Staff Report & Recommendation — Historic Preservation Board

SUBJECT: HPB24-0641, **1800 Michigan Avenue**.

An application has been filed requesting a Certificate of Appropriateness for the total demolition of the existing single-family home and the construction of a new single-family home.

1800 Michigan Avenue, 1953 photograph

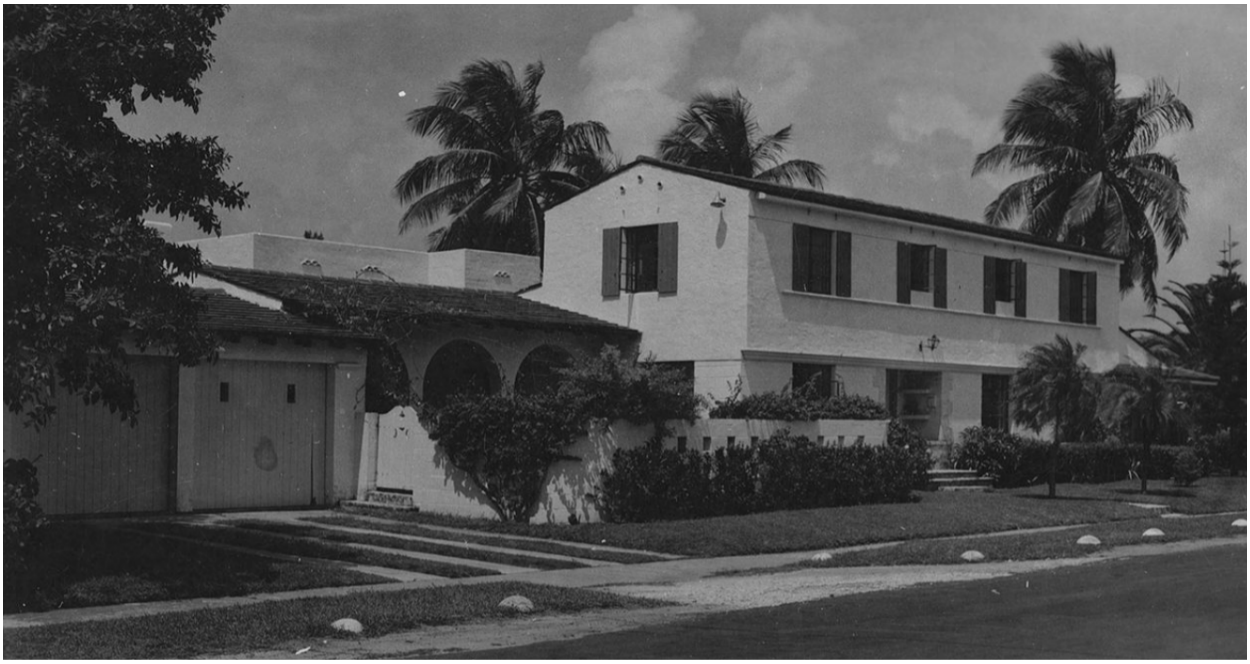
The existing home located at 1800 Michigan Avenue is relatively intact based upon aerial photographs and historical documentation. In 1968, the building card indicates that the garage was converted into additional living quarters. Additionally, based upon aerial photography, it appears that between 1985 and 1994, two unpermitted 1-story additions were constructed (to the north of the 2-car garage and to the south of the covered loggia).

Staff certainly understands that the unpermitted additions must be removed. Additionally, staff would note that there are no active unsafe structures violations, and based upon the structural report, it appears that the home can be repaired. As such, staff recommends that the application be continued to a future meeting date to allow for further investigation of the structural systems to determine if all or portions of the home can be repaired. Further, staff is open to working with the applicant to explore possible partial demolition and reconstruction and/or a new additions.
